Access Compliance Report

Public Rights-of-Way

(Curb Ramps)

| Intersection ID: 2710 | Main Street: FAIRVISTA_DR | Cross Street: QUEENSBURY_CT | Location: NW |

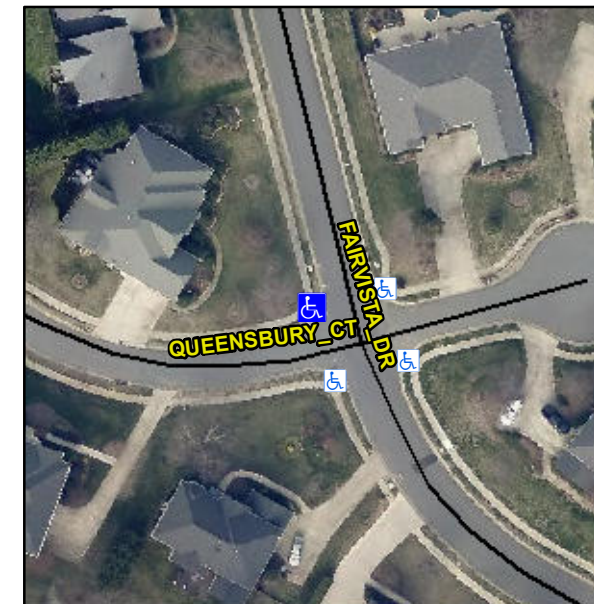
| ADA ID: A11CF6698D4B | Ramp Type: PerpDiag | Initial Pass/Fail: Pass | Overall Compliance: No |

Not Found, R304.2.2-Perp, R304.3.2-Para, R305

| Compliance | Description | Data | Compliance | Description | Data |
|------------|-----------------------|--------|------------|-----------------------------|------|
| Yes | Landing Length (in) | 55.0 | No | DWS Provided? | No |
| No | Landing Slope (%) | 4.4 | N/A | DWS Length (in) | N/A |

Remove & Replace Curb Ramp With Two New Directional Ramps or Equivalent.
